Add Washers to Mid Aero Shield and Rear Diffuser Fasteners

Classification	Campaign Bulletin	Section/Group	12 - Exterior Fittings	Country/Region	United States
Year	2016	Model	Model X	Version	All

Figure 1

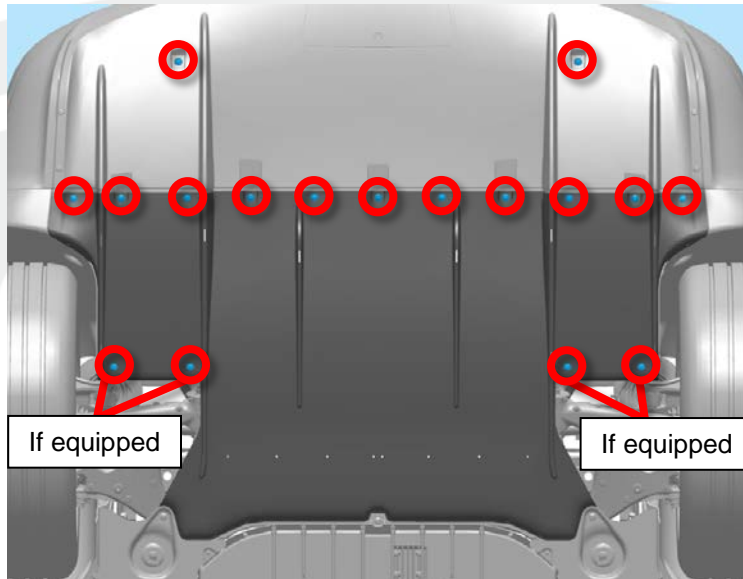
Some Model X vehicles were built without washers on the fasteners that secure the mid aero shield and rear diffuser. This could allow the mid aero shield or rear diffuser to become detached from the vehicle in extreme driving conditions.

NOTE: On some early Model X vehicles, the mid aero shield is not equipped with the 4 forward fasteners shown.

2. Inspect the mid aero shield and rear diffuser for washers on the fasteners shown (Figure 1).

Install washers on the fasteners that secure the mid aero shield and rear diffuser.

- If all fasteners have washers, no additional work is required. Lower the vehicle and discontinue this procedure.
- If any of the fasteners are missing a washer, remove the fastener and reinstall it with a washer (torque 4 Nm).
